Approved Section 4.55 (2) Modification Application

No: SSD 6966 MOD 1 Granted on 19 August 2021

ONE SYDNEY HARBOUR

BARANGAROO

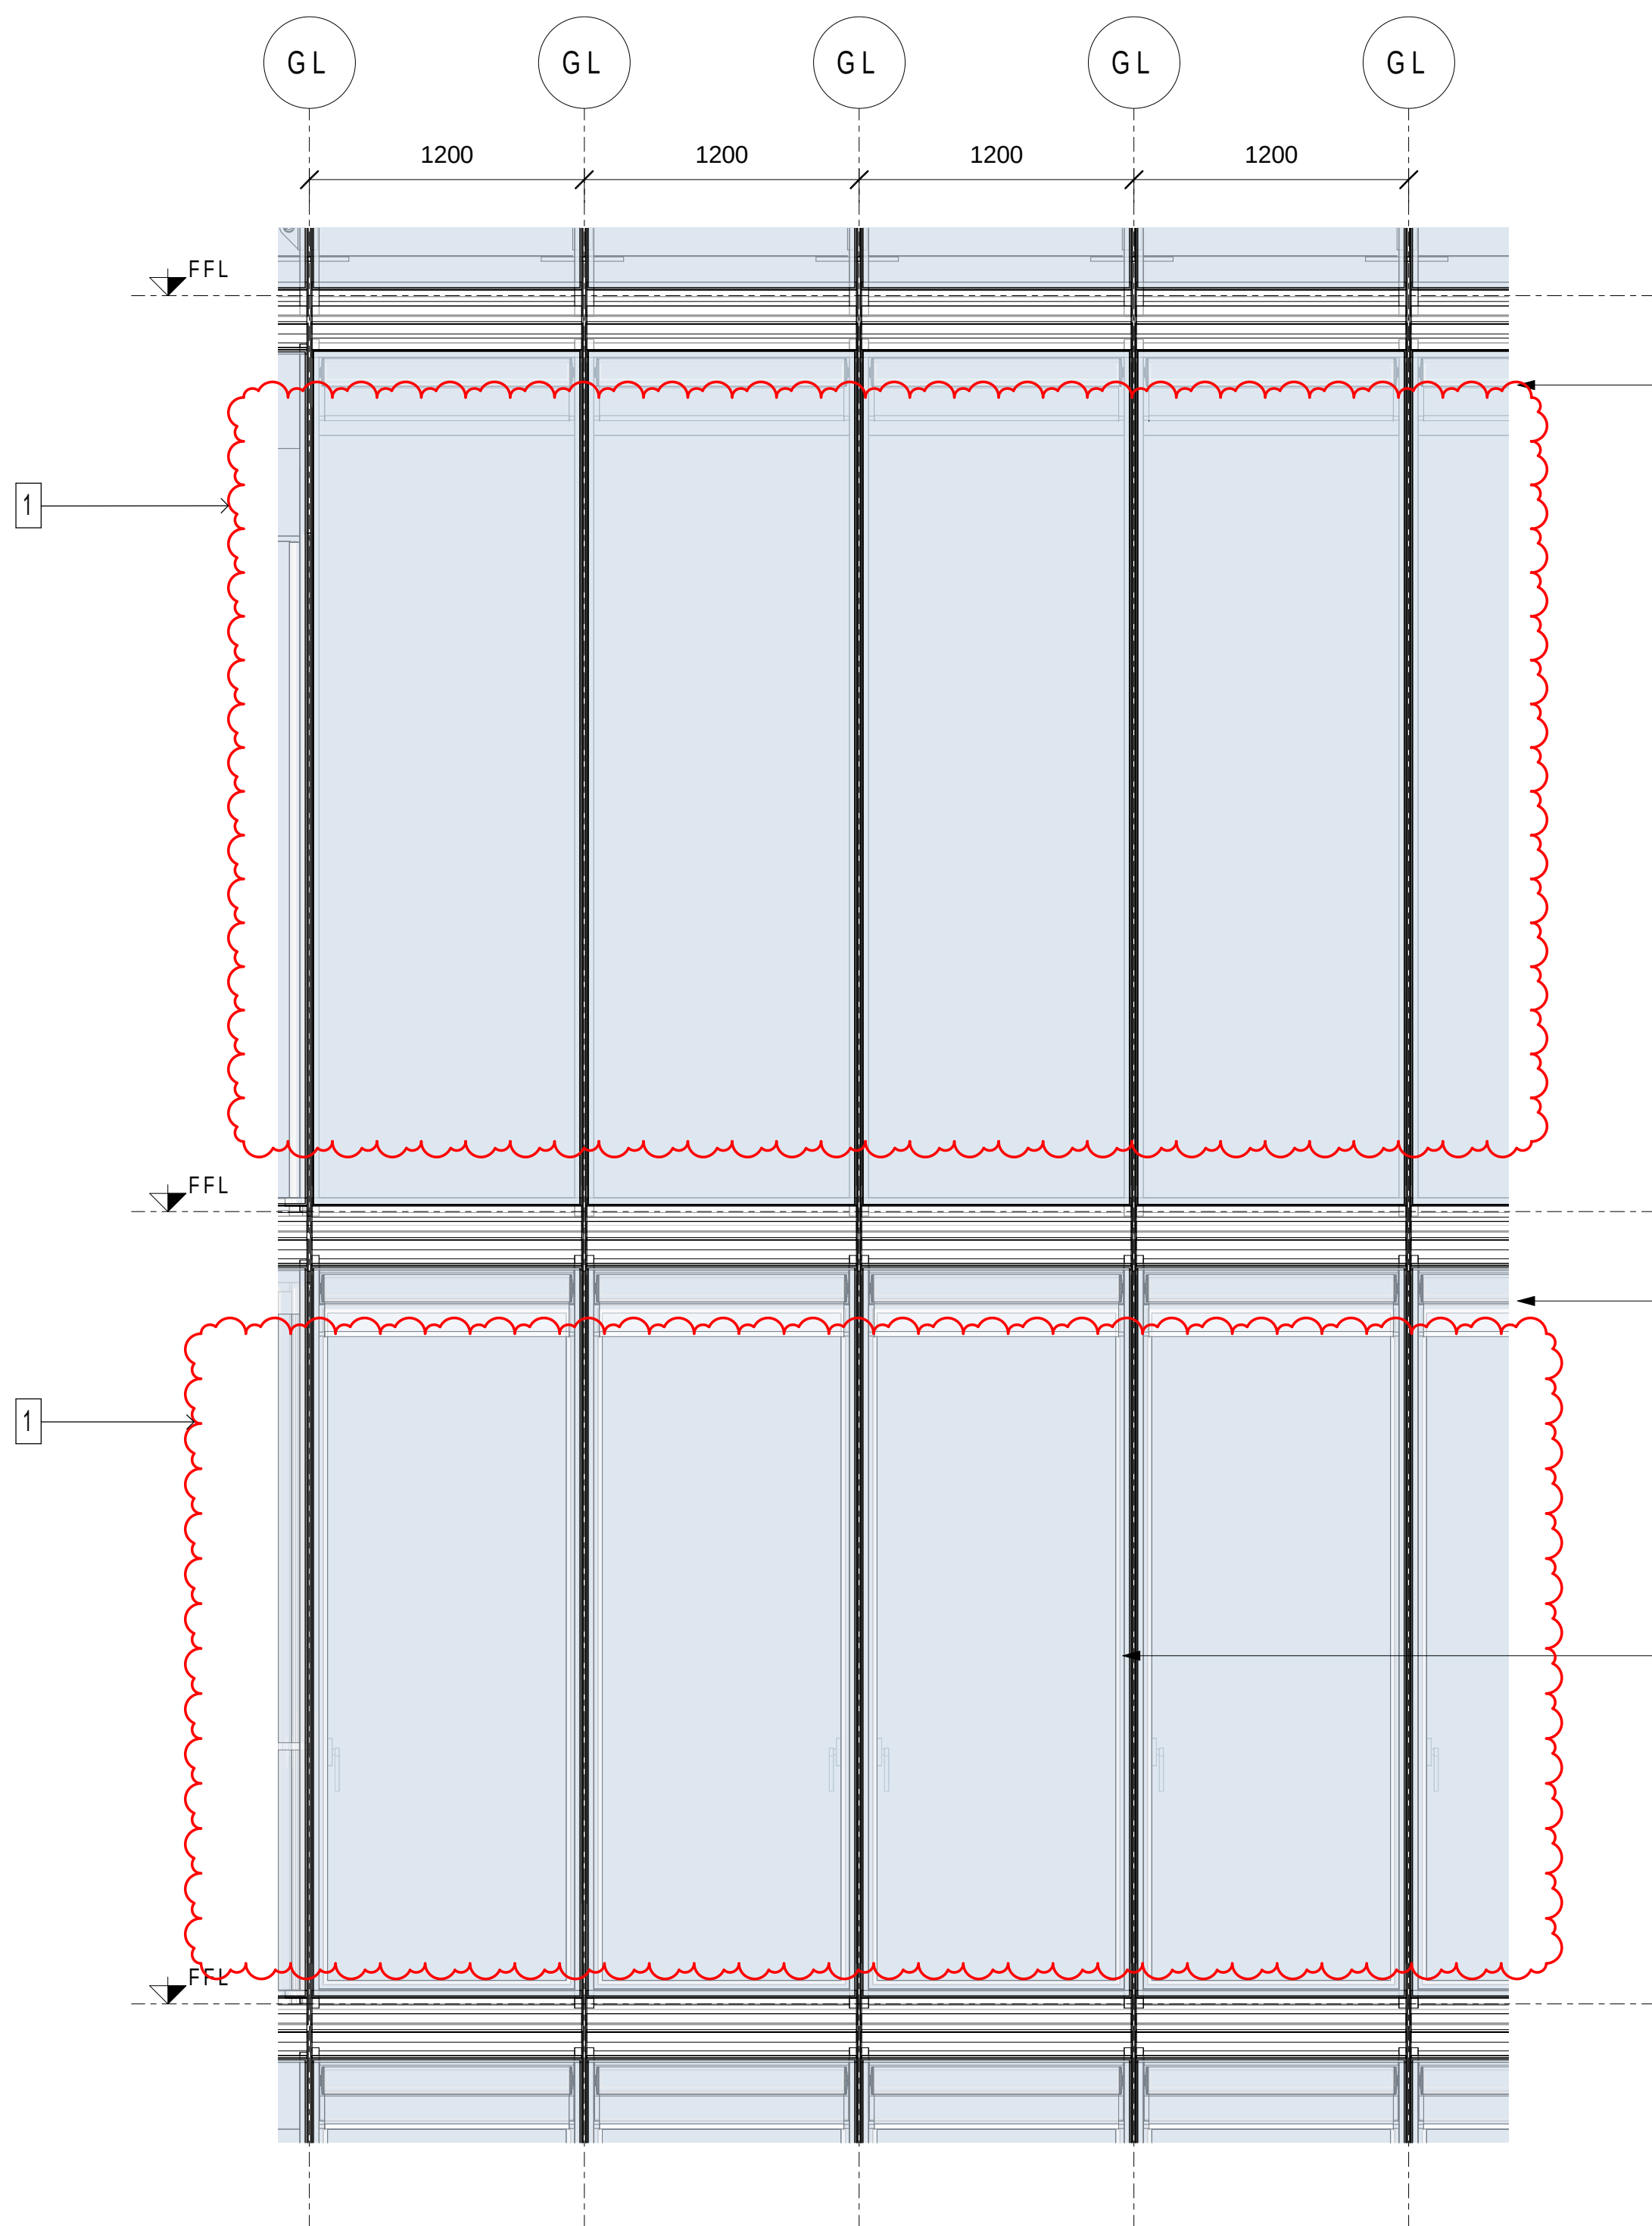
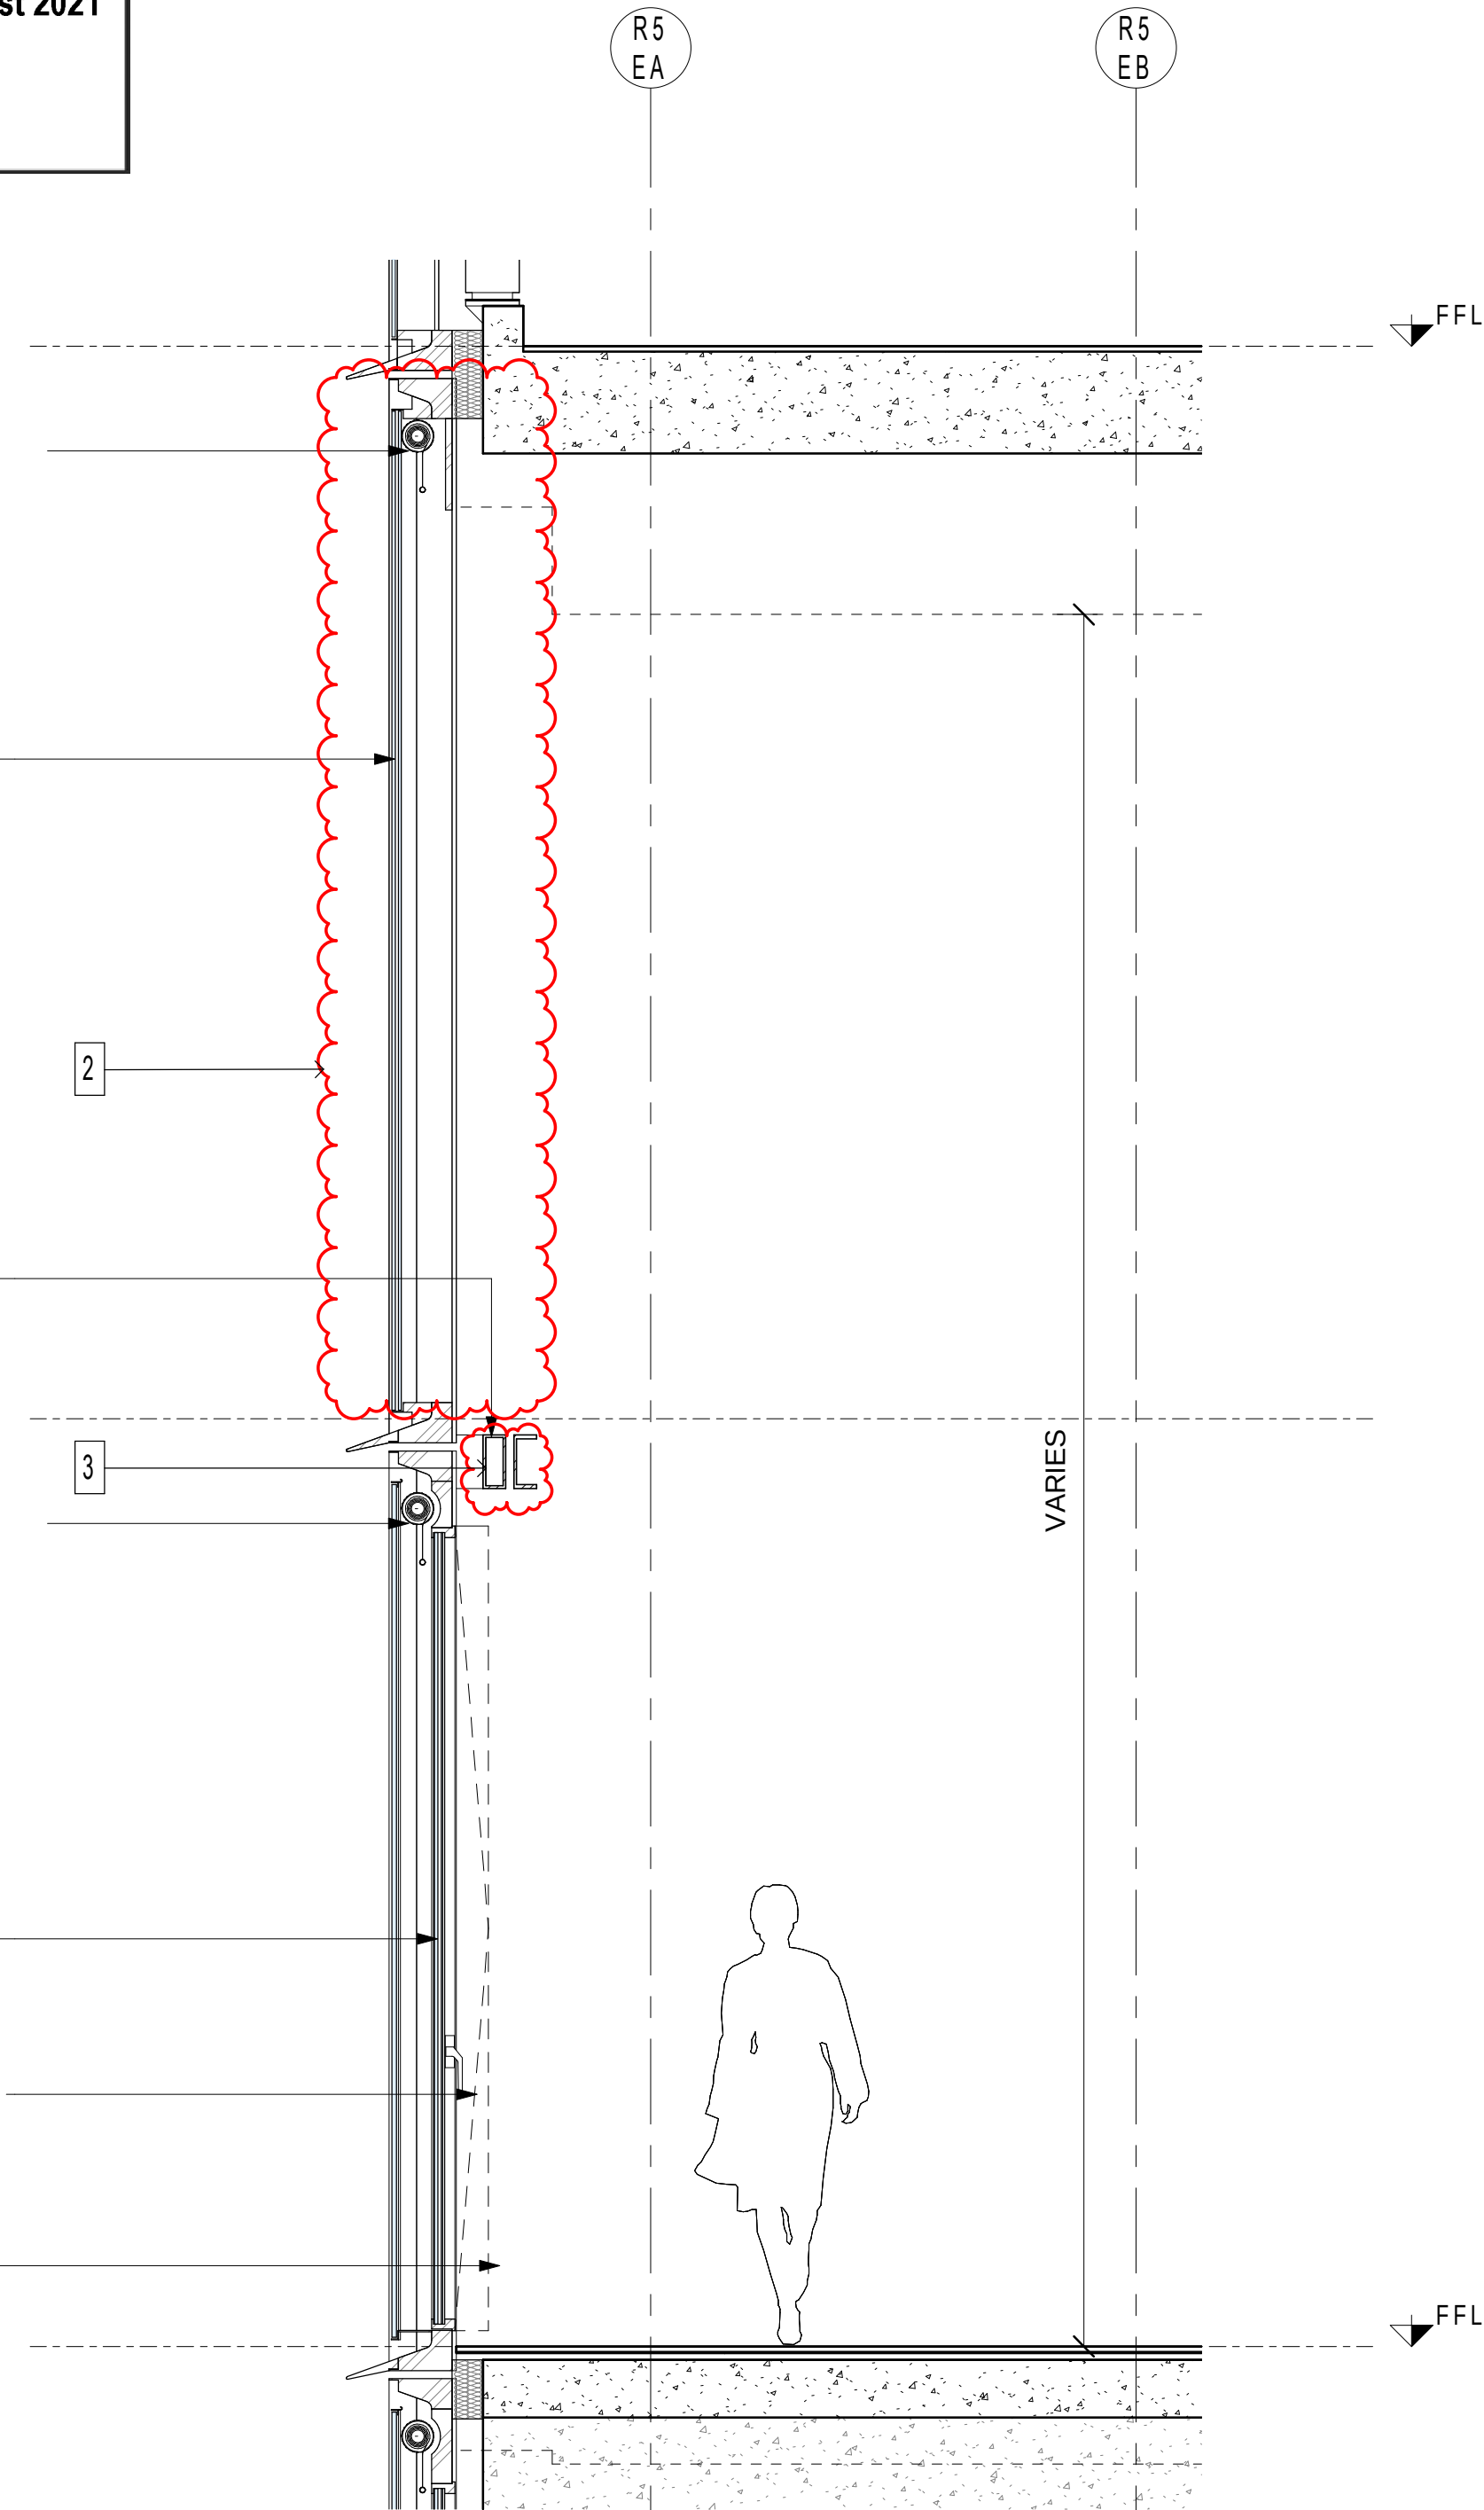
1. REMOVED EXTERNAL SHADING DEVICES
2. FACADE CHANGED TO FIXED DGU
3. UPDATED STEEL STRUCTURE

1 Secondary Facade - Closed Cavity Facade - Elevation
1 : 25

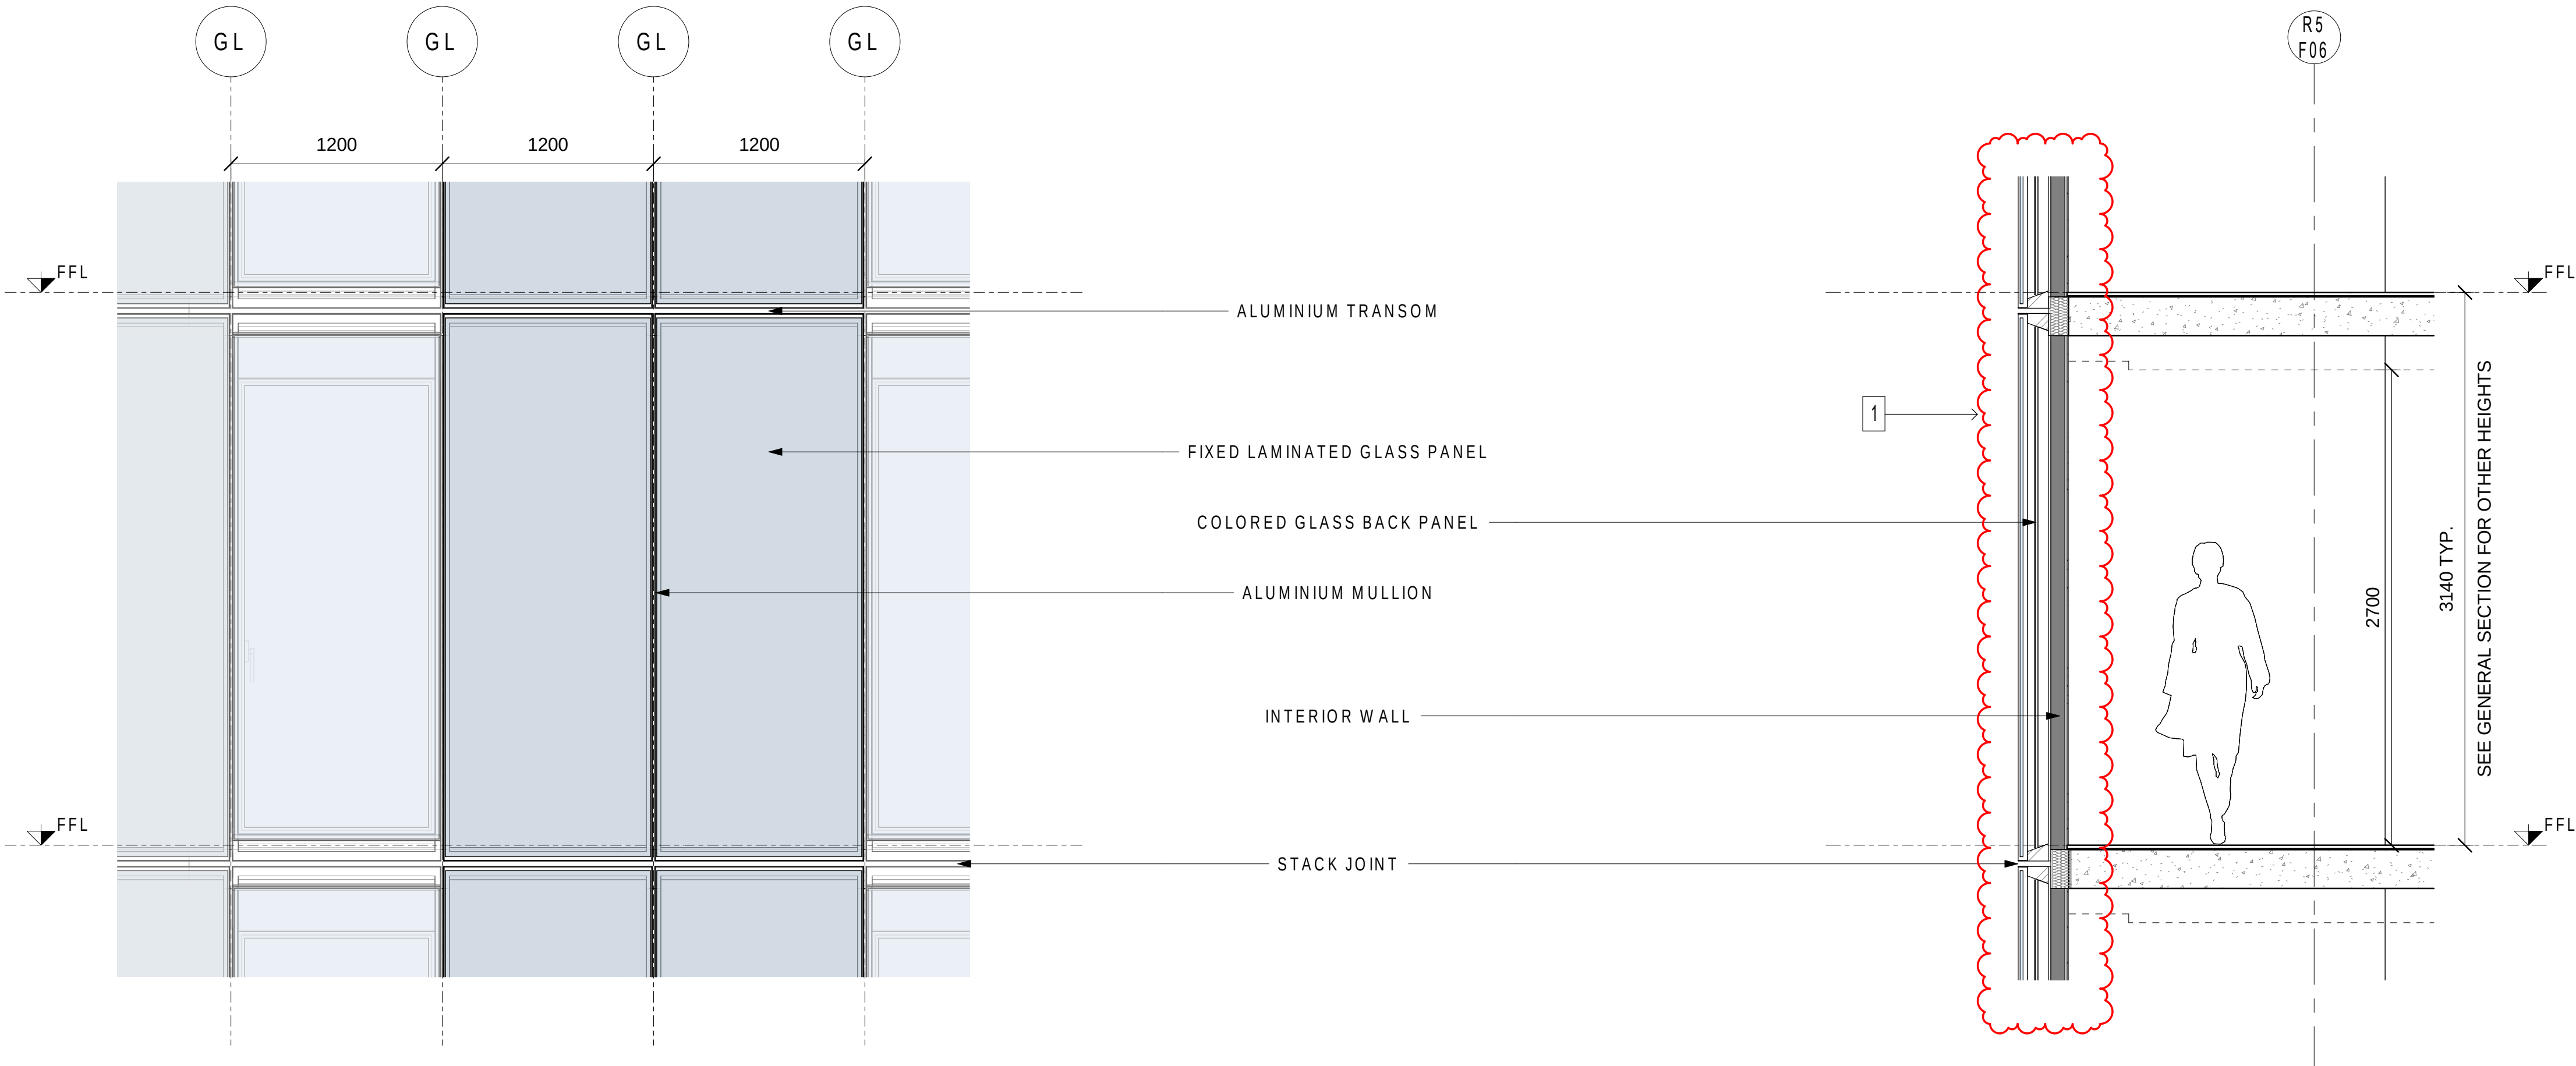
MODIFICATION:
1. ADDED COLORED GLASS BACK PANEL
